Bulletin
Number 5046

LAND-ROVER

ROAD SPRINGS

Fig. 1

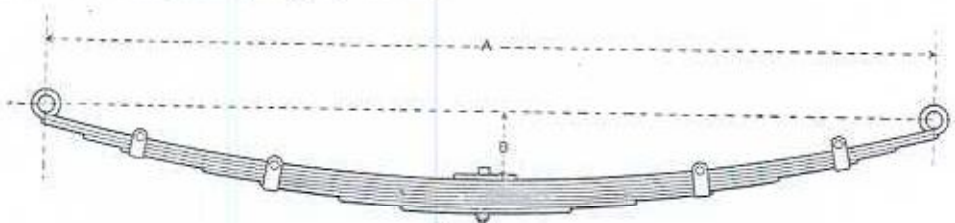
Several changes have been made in the design of Land-Rover road springs; details of these alterations are set out below to assist in the correct maintenance and replacement ordering for the vehicles concerned.

The **FREE CAMBER** of the spring, when removed from the vehicle, is used as an identification feature. It is indicated by the measurement "B" at Fig. 1, *i.e.* the distance from the top of the main leaf to the line joining the spring eye centres.
